Item 5 - Report on Planning Applications

Application Ref: NP/13/0441

Application Type	Full
Grid Ref:	SM87422078
Applicant	Mr I Bowie, Humbergrange Ltd
Agent	Mr Tim Colquhoun
Proposal	Demolition of existing Motel & replace with 40 bed hotel with adjoining restaurant & associated parking & landscaping
Site Location	Rochgate Motel, Roch, Haverfordwest, Pembrokeshire, SA62 6AF
Case Officer	Liam Jones

DATE	23.10.13	CH/09/10
	SCALE	1 : 250
PROJECT	THE GATE HOTEL, ROCHGATE	
DRAWING	ROOF PLAN	
©	TIM COLQUHOUN ARCHITECTS LTD	0 1 2 3 4 5
	SLALEY WOOD, LITTLE LOSTON, PERM., S769 0NR	MOB: 07986 093801
	TEL / FAX : 01834 891555	Scale in metres

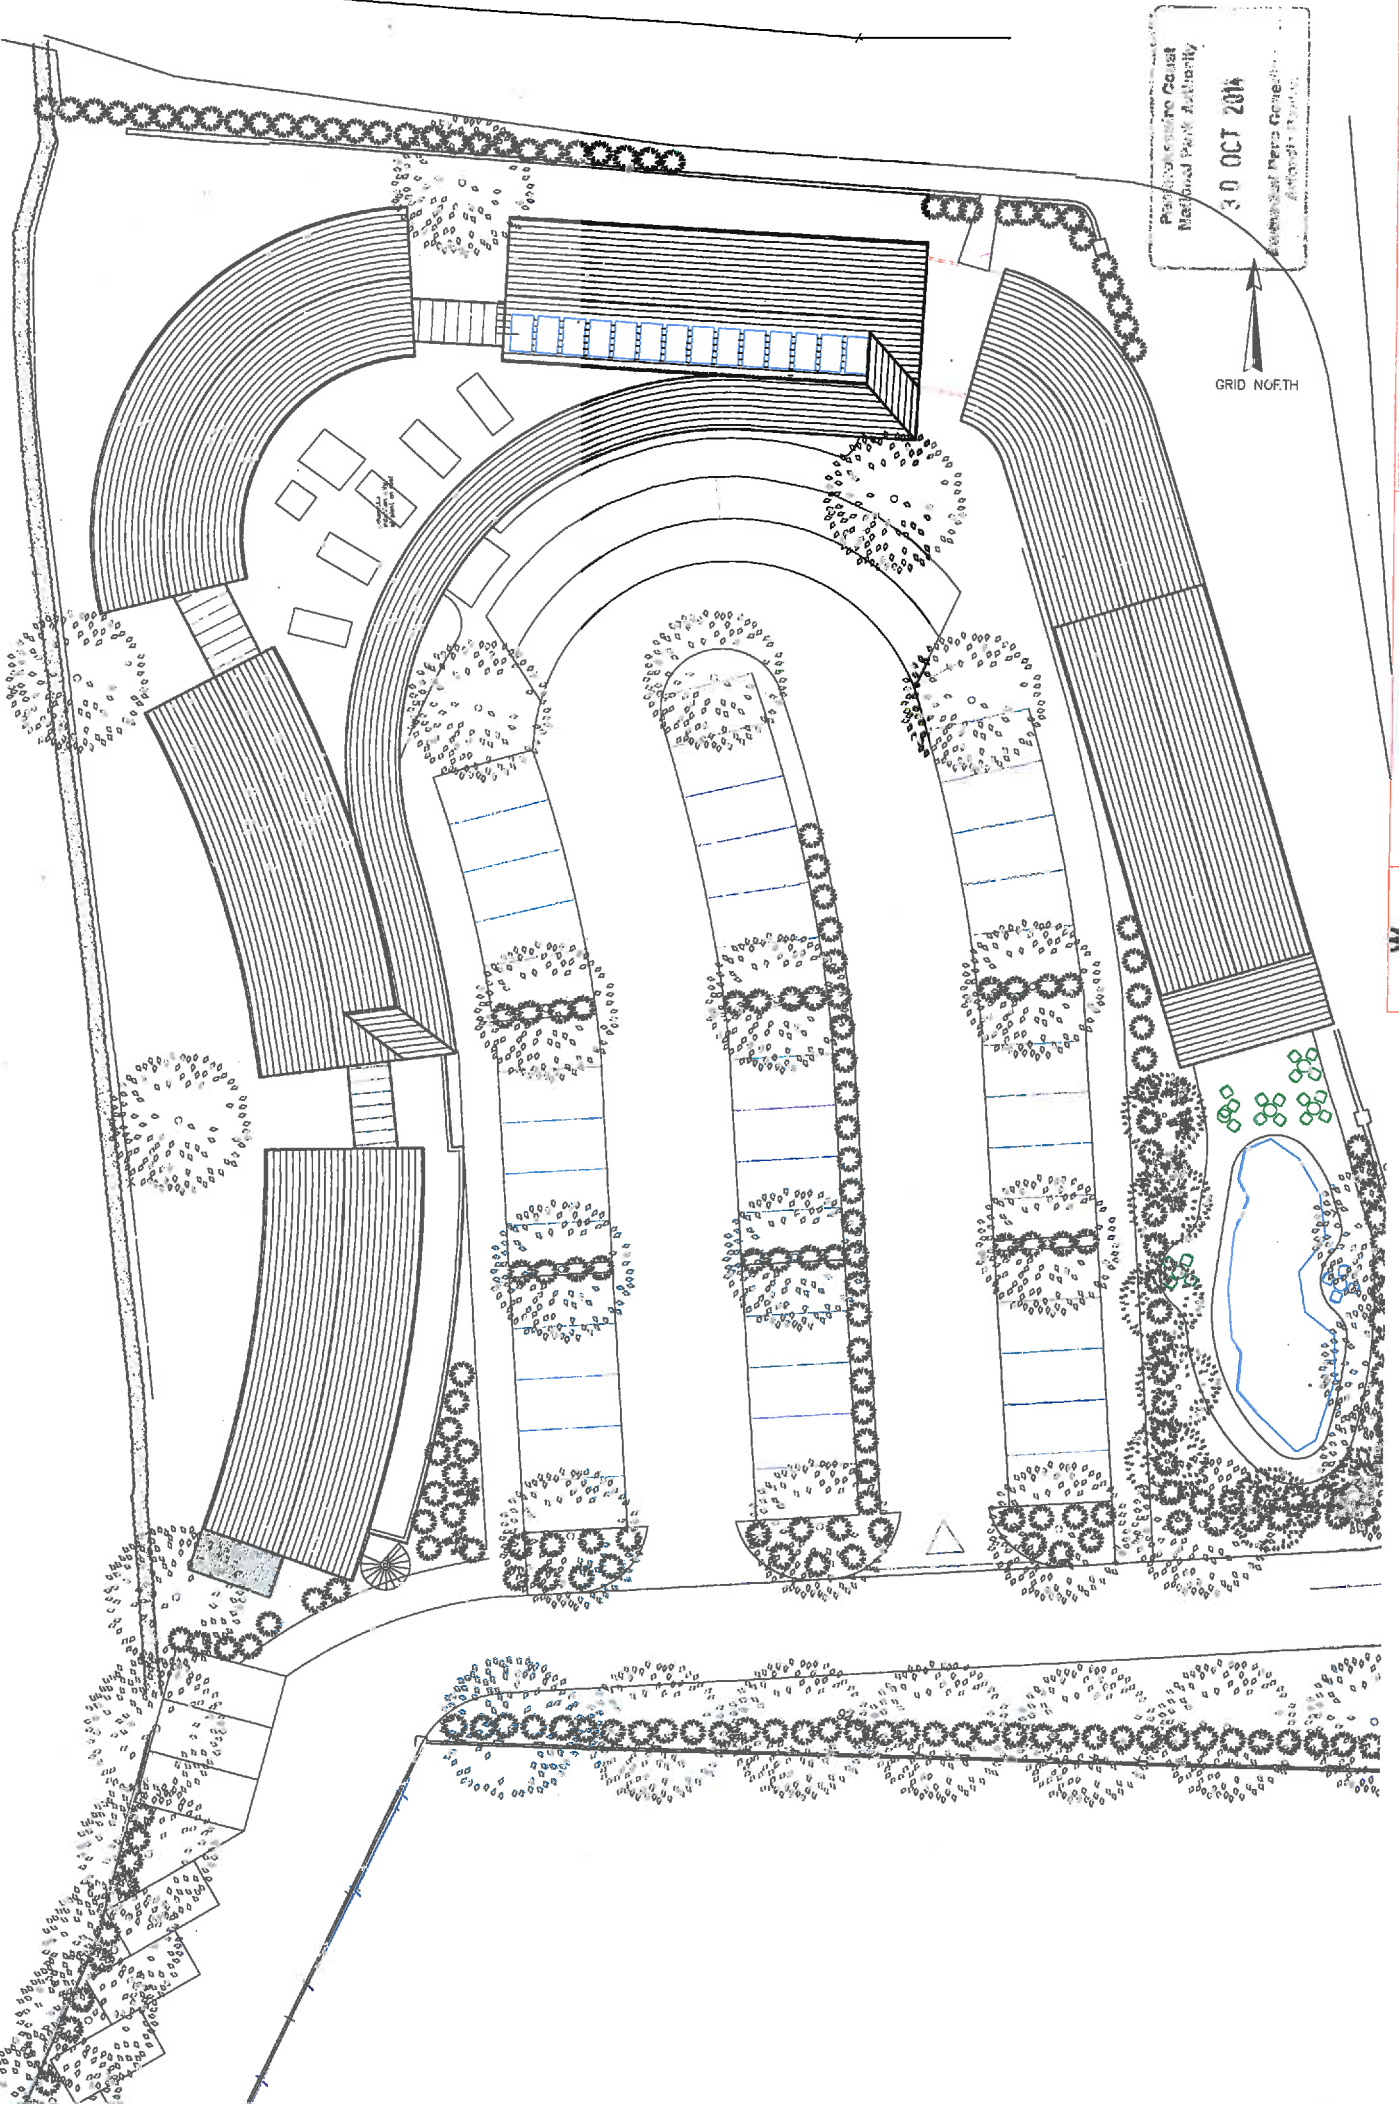
The concerns about the design of the flat roof have been addressed through the creation of a false roof projecting from the front of the building to give the impression of a traditional roof formation. The drawings provided need some amendments to be carried out in relation to the detailing of this roof as well as the finishing to each of the elevations. The applicant has also suggested omitting the stone from the entrance elevation given that it appears a heavy addition to this part of the scheme.

PROPOSED SECTIONS AND ELEVATIONS

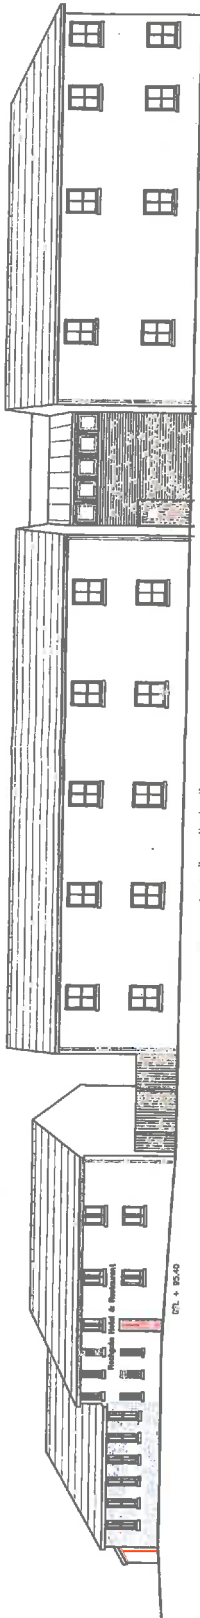
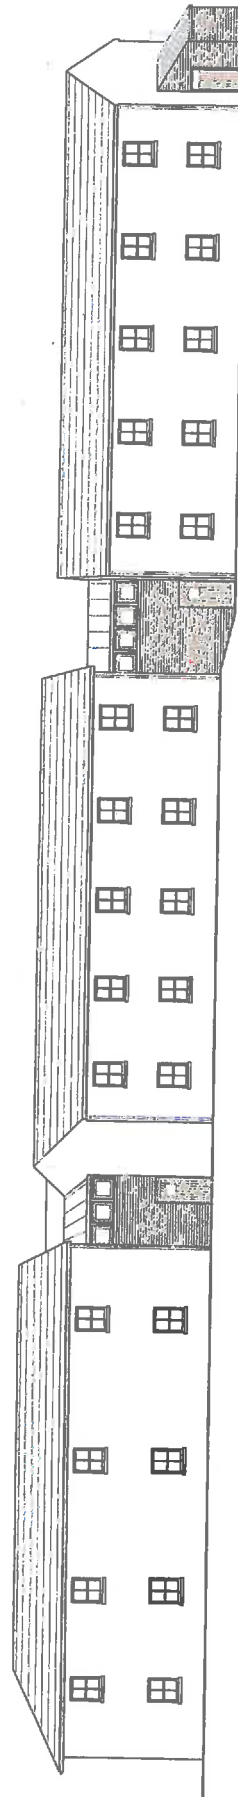
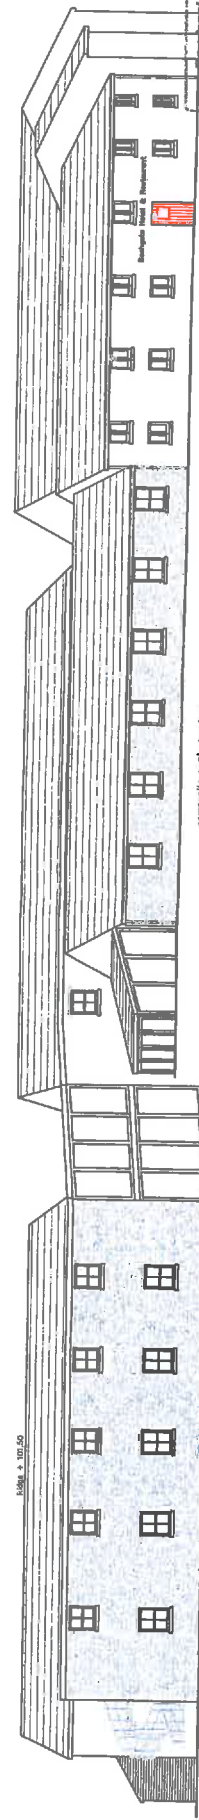
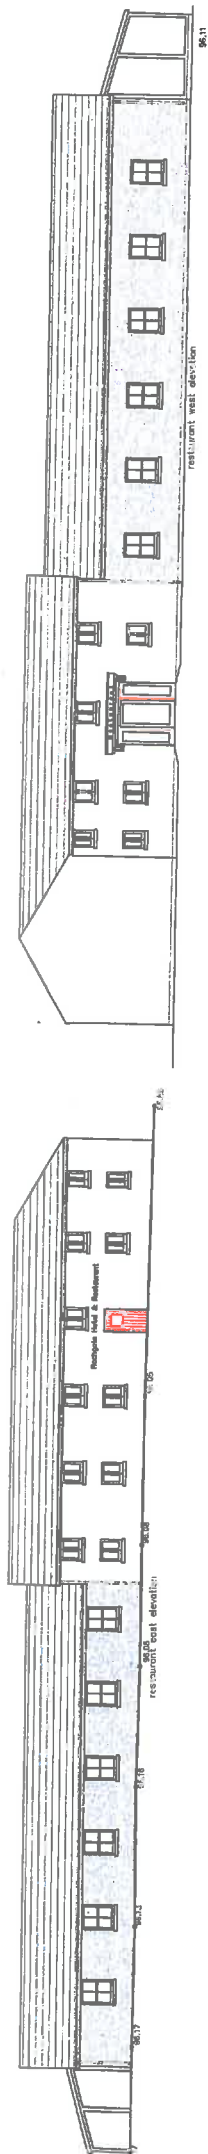
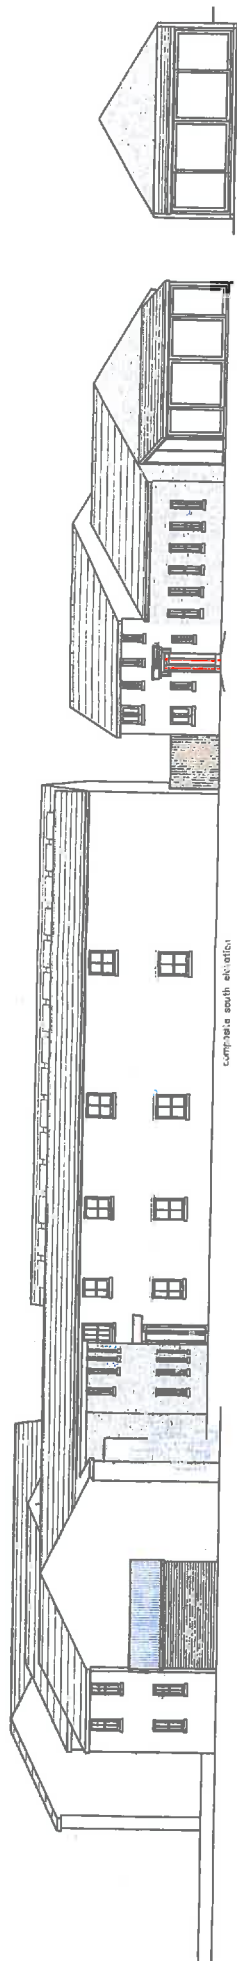
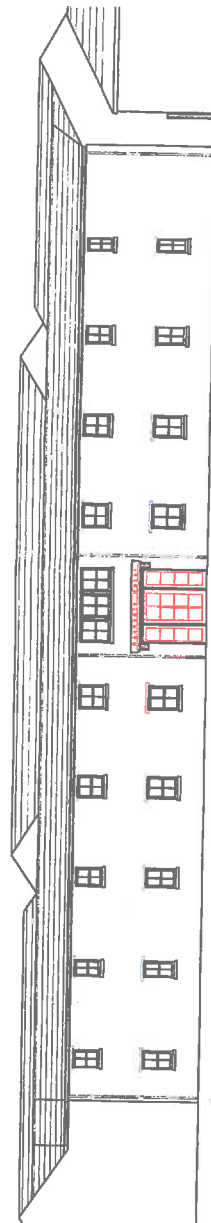
Officers note that the drawings are 'draft' in so far as additional drawings showing the full site layout are required and that drafting errors relating to the aspect of new false roofing have been omitted from east context elevation and the south elevation shows stonework to the hotel lobby which has been removed from the main hotel entrance elevation. The applicant will be required to address these inconsistencies with a new schedule of drawings.
